INFORMATION BRIEFING

TO: Outfall Monitoring Science Advisory Panel, Dr. Andrew Solow, Chair
FROM: Dr. Andrea Rex, MWRA
DATE: October 28, 2009
RE: Proposed Revisions to MWRA's Outfall Ambient Monitoring Plan for Water Column monitoring

Figure 3 Existing and proposed water column stations

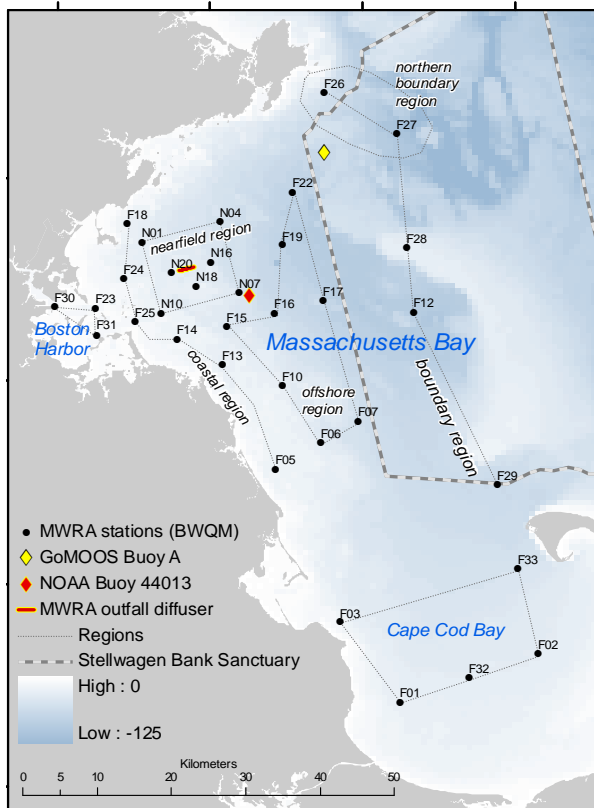
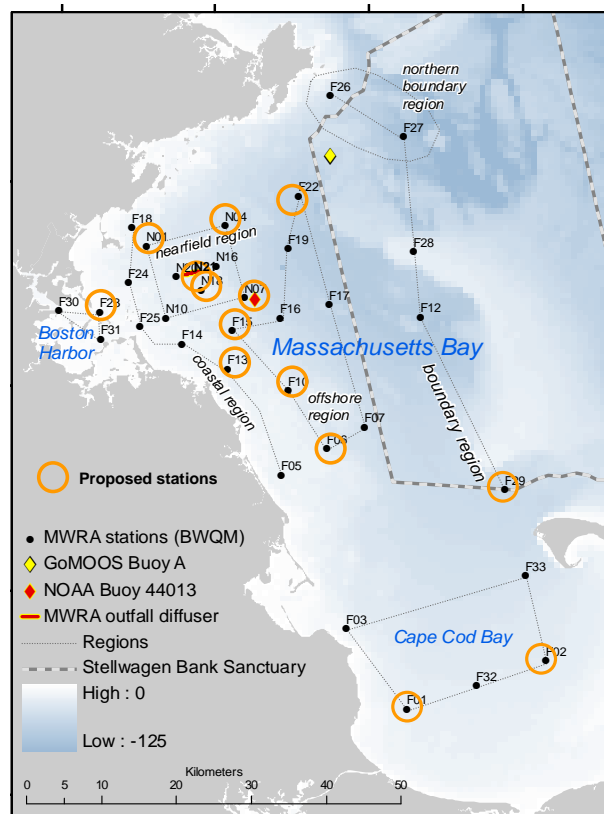
- 2.1 **Reduce the total number of stations sampled from 33 to 14.** This change focuses the monitoring on the geographic area now known to have a possibility of being affected by the discharge. Reference stations are included, but most of the furthest stations are removed.

- 2.1.1 **Delete the following stations: F03, F05, F07, F12, F14, F16, F17, F18, F19, F24, F25, F26, F27, F28, F30, F31, N10, N16, N20.**
 - 2.1.2 **Include the following stations: F06, F10, F13, F15, F22, F23, N01, N04, N07, N18, N21 (Figure 1, Table 1).** Measure dissolved nutrients at nearfield station N21 at the edge of the zone of initial dilution, 60 meters from midline of diffuser line.

- 2.1.3 **Sample three stations in Cape Cod Bay-Stellwagen Bank National Marine Sanctuary: F01, F02, F29 (Figure 1, Table 2).** Parameters will include *in situ* water quality, water column chemistry, and plankton, sampled 9 times annually at two depths.

Sampling locations: To help put the proposed new design in context with the previous and existing design Figures 2 and 3 show how the new design focuses on locations where plankton data have historically been collected. That is, most of the present stations not included in the proposed design are chemistry-only stations. MWRA chose the stations in Cape Cod Bay because these are the two locations where comprehensive measurements (including plankton) have historically been performed, and the Stellwagen site was suggested by SBNMS.

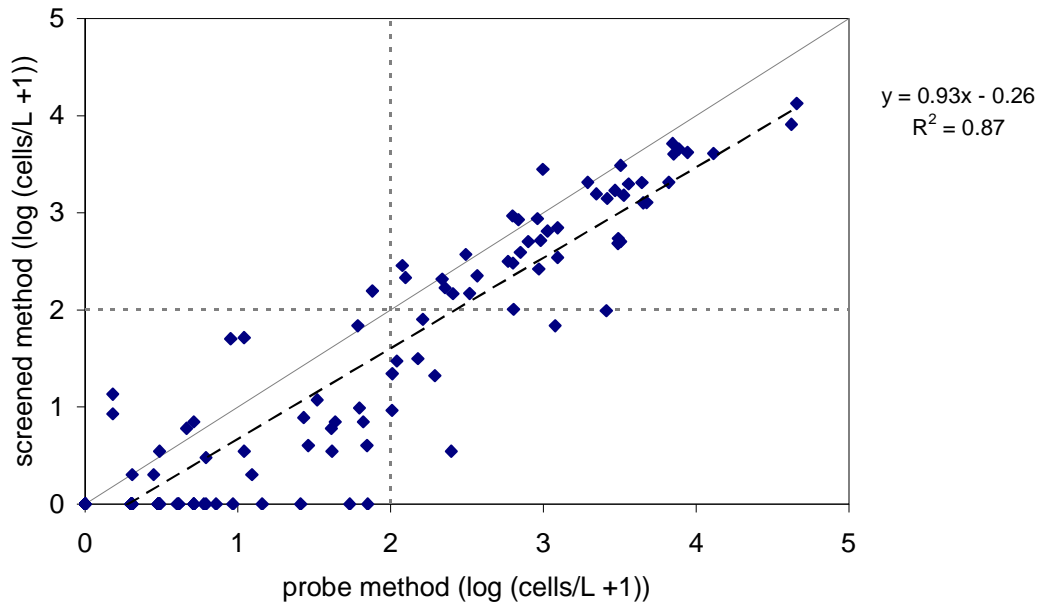
Alexandrium methods. OMSAP had requested a comparison of the newer gene probe method of detecting and enumerating *Alexandrium* with the previous method. One question was whether this would change the frequency of Contingency Plan threshold exceedances. Figure 4 and Table 5 show that the probe method is somewhat more sensitive than the older method, but that the threshold exceedance rate is similar. (Nine out of 52 samples exceeded the threshold with the probe method but were below the threshold with the older method). The main advantages of the probe method are its accuracy and speed, which are important to determining when and where to sample during a red tide event.
